## Road Safety Assessment (RSA)

SR 84 – Niles Canyon Corridor  
Alameda Co., California  
May 2012

Figure 21: Modern roundabouts have fewer conflict points and fewer crashes

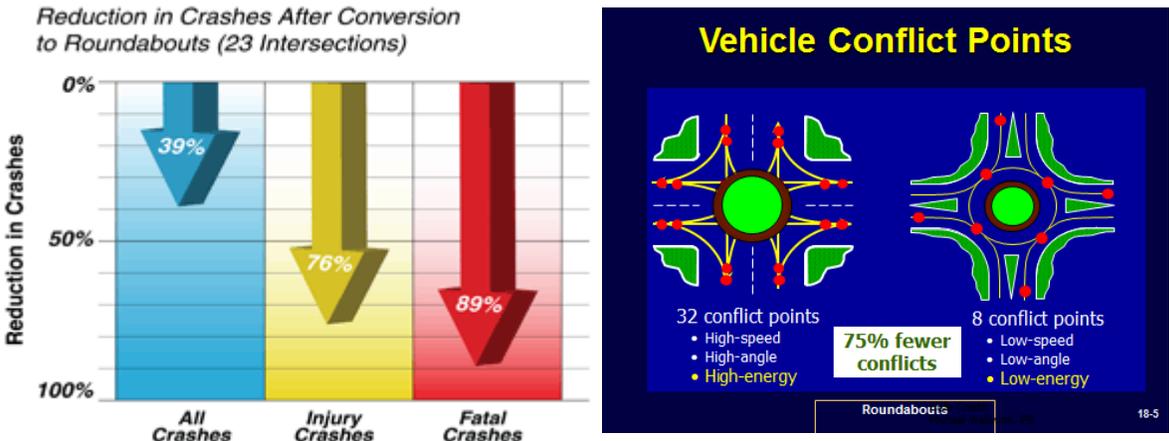
*Signalizing the Water Temple intersection might help reduce some of the queuing, however the team believes an even more effective choice would be to consider a modern roundabout in these locations.* Reduction or elimination of queuing at the Water Temple and near the school in Sunol has the potential for not only improving safety by crash reductions but also by reducing the informal short cuts during queues through Sunol, especially near the school.
